Subject: Reeds Cove Medical Campus Addition

I reviewed the Drainage Report for the above referenced subdivision and have the following comments and necessary revisions:

DRAINAGE REPORT
Reeds Cove Medical Campus Addition
WICHITA, SEDGWICK COUNTY,
KANSAS

DRAINAGE MAP

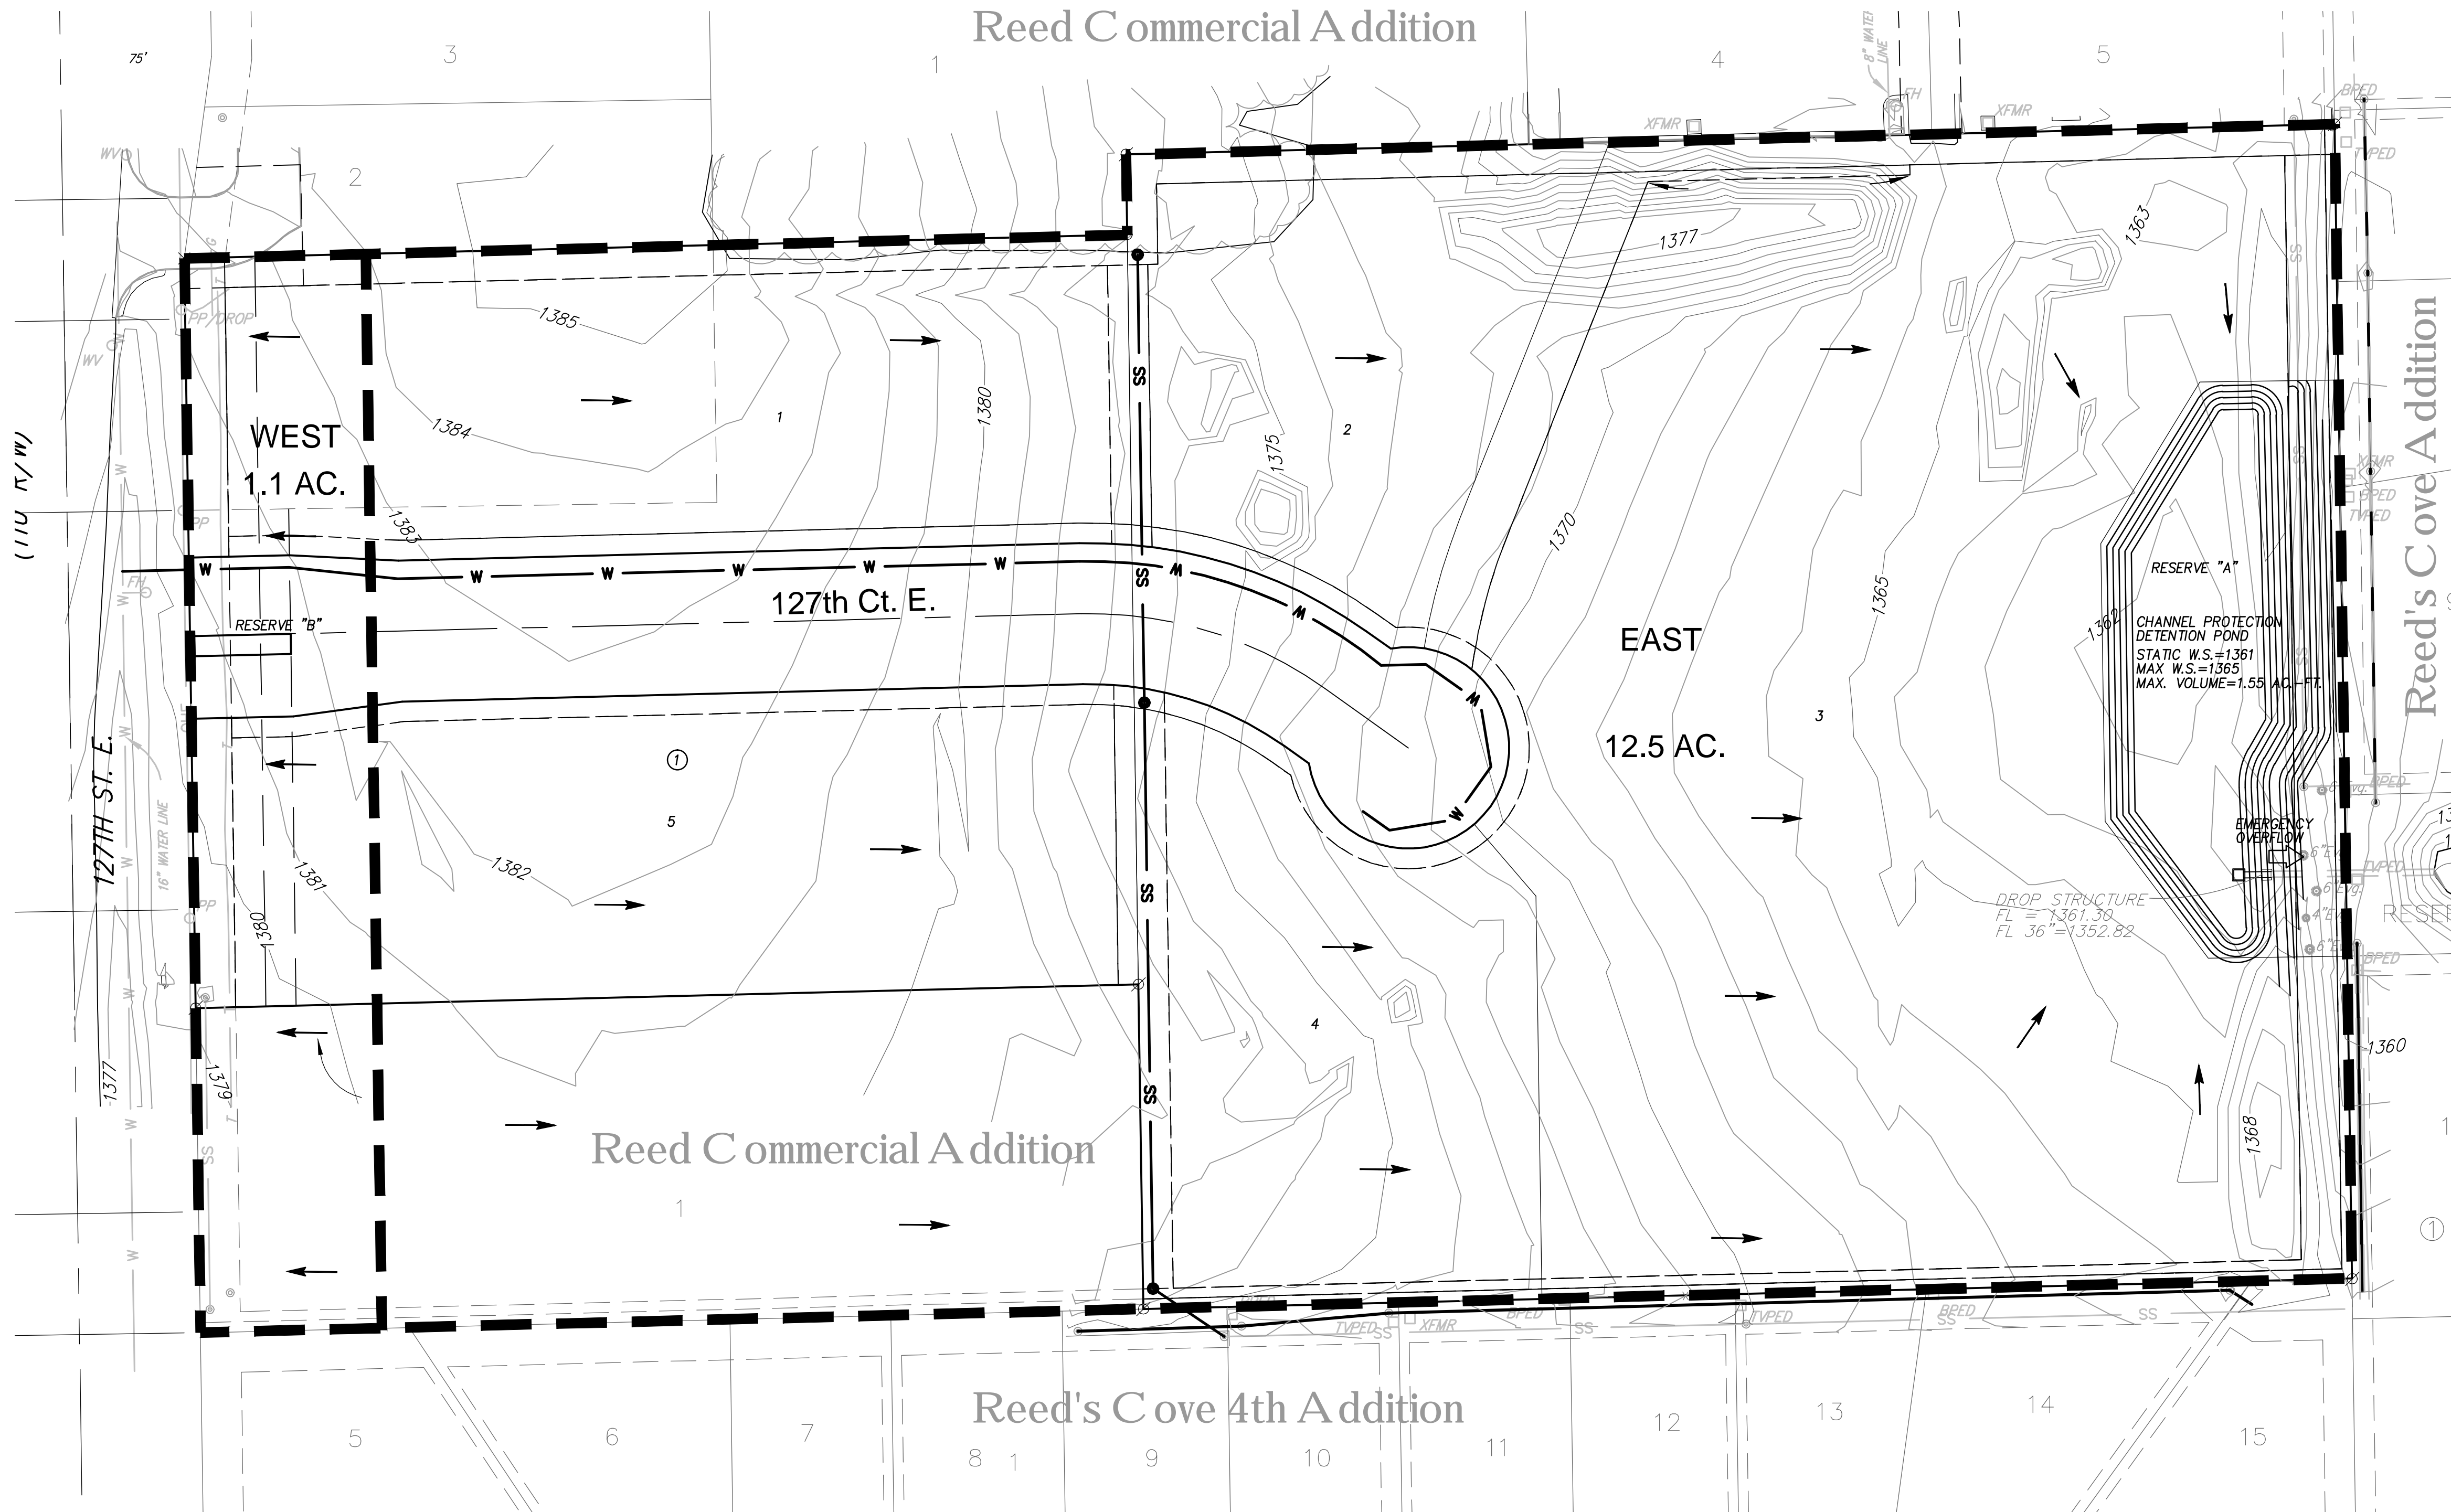
6. Proposed flow arrows are not specific in the easterly portion of lot 3. I want to make sure that all drainage will be routed through the proposed channel protection detention pond, rather than draining to the south into Reeds Cove 4th Addition or east to Reeds Cove Addition *- Revised, see Drainage Map*
